Access Compliance Report

Public Rights-of-Way (Curb Ramps)

Intersection ID: 8389	Main Street: N LINWOOD_AV	Cross Street: ROZZELLES_FERRY_RD	Location: NW
ADA ID: 0CD5C8A2216A	Ramp Type: Directional1	Initial Pass/Fail: Fail	Overall Compliance: No
Severity Score: 12.5			
Codes/Mitigation Info/Possible Solution		Field Measurements/Component Compliance

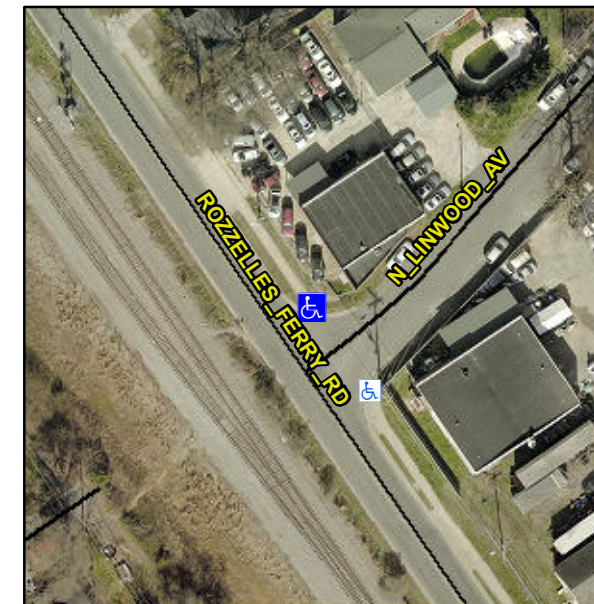
R304.2.2

Compliance	Description	Data	Compliance	Description	Data
N/A	Ramp Length (in)	83.0	N/A	Grade Break?	N/A
Yes	Ramp Width (in)	72.0	N/A	Grade Break Slope (%)	0.0
No	Ramp Slope (%)	9.3	N/A	Grade Break XSlope (%)	0.0
Yes	Ramp XSlope (%)	0.5			
N/A	Flare Type LT	N/A	N/A	Flare Type RT	N/A
N/A	Flare Slope LT (%)	N/A	N/A	Flare Slope RT (%)	0.0
N/A	Flare Traversable LT?	N/A	N/A	Flare Traversable RT?	N/A
N/A	Landing Length (in)	0.0	N/A	DWS Provided?	N/A
N/A	Landing Width (in)	0.0	N/A	DWS Contrast?	N/A
N/A	Landing Slope (%)	0.0	N/A	DWS Length (in)	N/A
N/A	Landing X Slope (%)	0.0	N/A	DWS Full Width?	N/A
N/A	Landing Curb? (Y/N)	N/A	N/A	DWS Offset LT (in)	N/A
N/A	Shared Landing?	N/A	N/A	DWS Offset RT (in)	N/A
N/A	Gutter Ponding?	0.0	N/A	Gutter Slope (%)	N/A
N/A	Gutter Lip Ht (in)	0.0	N/A	Gutter X Slope (%)	N/A
N/A	Painted X Walk1?	No		Road Slope (%)	1.5
	X Walk 1 Direction	To SE		Road X Slope (%)	2.0
	X Walk 1 Width (in)	N/A		Clear Space?	N/A

Remove & Replace Entire Ramp.
